RE-ENTRY SYSTEMS OPERATIONS
GENERAL ELECTRIC COMPANY • P.O. BOX 7722 • 89 MAR 28 AM 11:12
PHILADELPHIA PENNSYLVANIA 19101 • (215) 823-2000

March 25, 1983

This refers to your letter dated March 9, 1983, requesting additional information and clarification concerning GE/RSO's application for amendment to License No. SUB-831 (Docket or Reference No. 040-07344).

FLOOR PLAN OF GESCO WAREHOUSE, 401 EAST HUNTING PARK AVE., PHILA., PA
 (PORTION OF WAREHOUSE BETWEEN COLUMNS A7, V7, VII, & ALL IS OCCUPIED BY GE/RSO)

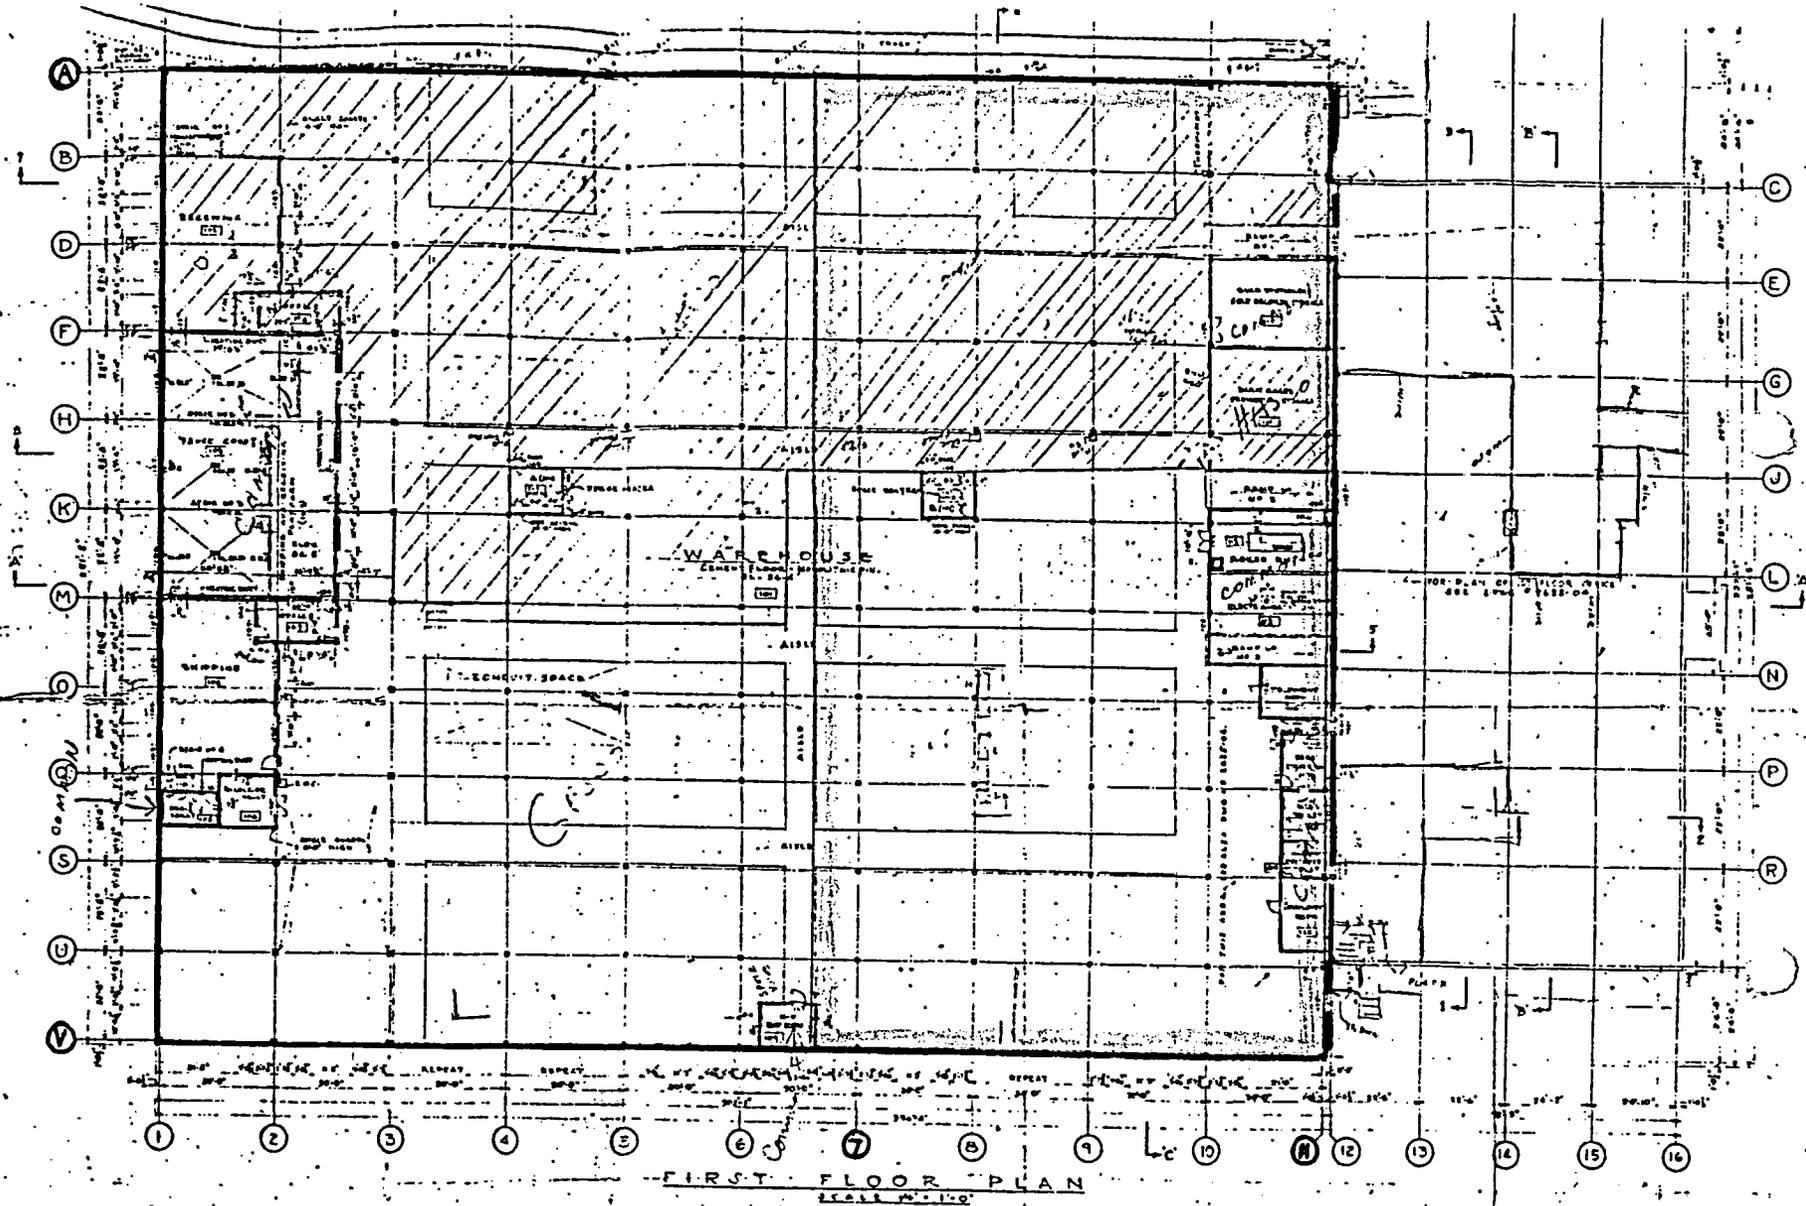
A layout of the warehouse facility on Hunting Park Avenue is attached. GE/RSO's portion of the facility consists of approximately 5000 square feet of floor space with a 20-foot high ceiling. The normal ventilation system provides approximately 1 room air change per hour. Literature from the vendor of the thoriated magnesium alloy states that indoor storage of sheets and plate does not result in unsafe airborne concentrations of thoron and decay products if alloys are stored in accordance with the recommendations for fire safety by the National Fire Protection Association.

TRACK LEVEL PLAN OF GE/RSO BUILDING, 3198 CHESTNUT ST., PHILA., PA 19101

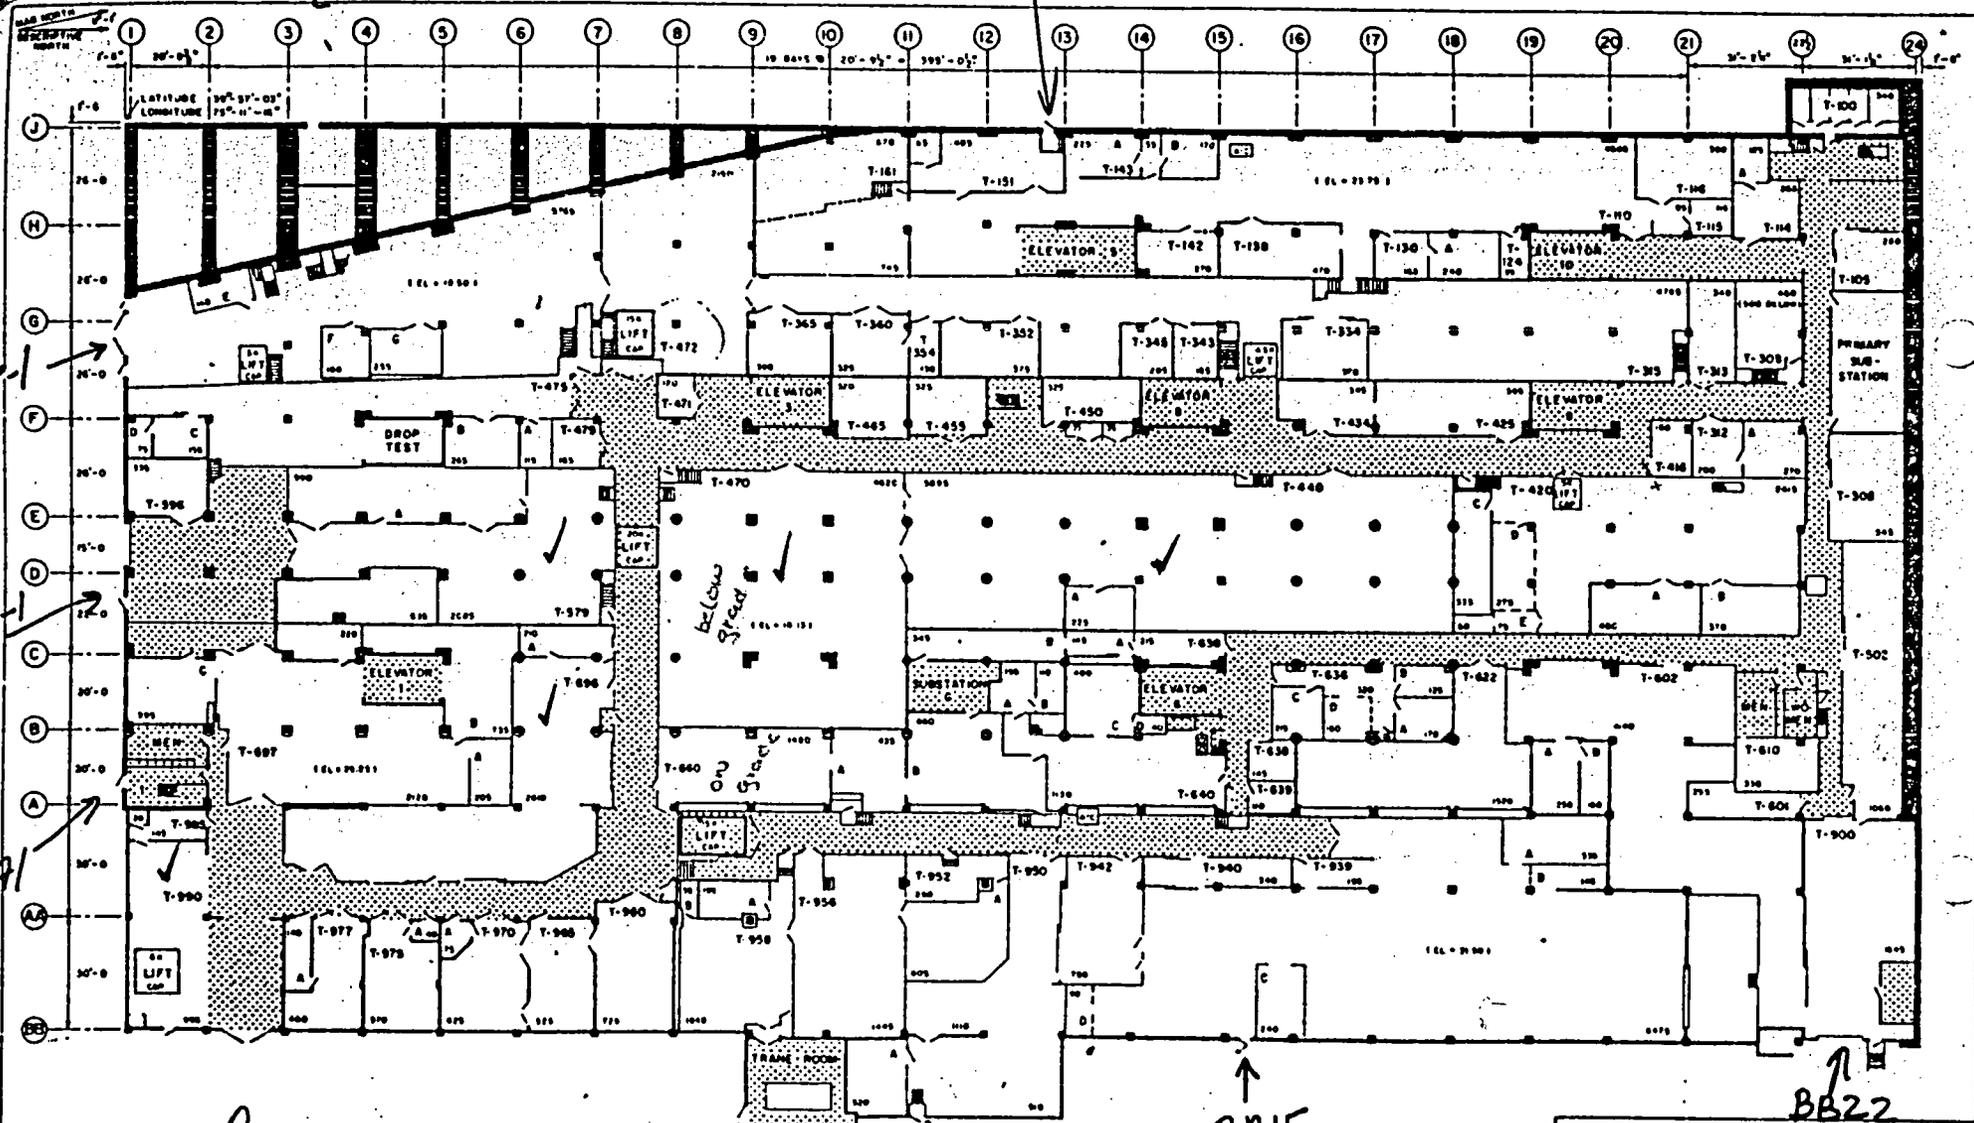
A floor plan of the track level of 3198 Chestnut Street is attached. The milling and drilling machine to be used is located between columns D8, D9, C8, and C9. A network of outside air supply ducts provide make-up air to a semi-closed air conditioning/ventilation system on this track level (approximately 0.5 room air change per hour). As stated in the application, our intention is to perform air monitoring during initial processing per Attachment 9.C.1 of that application. To further clarify our plan, please consider the following:
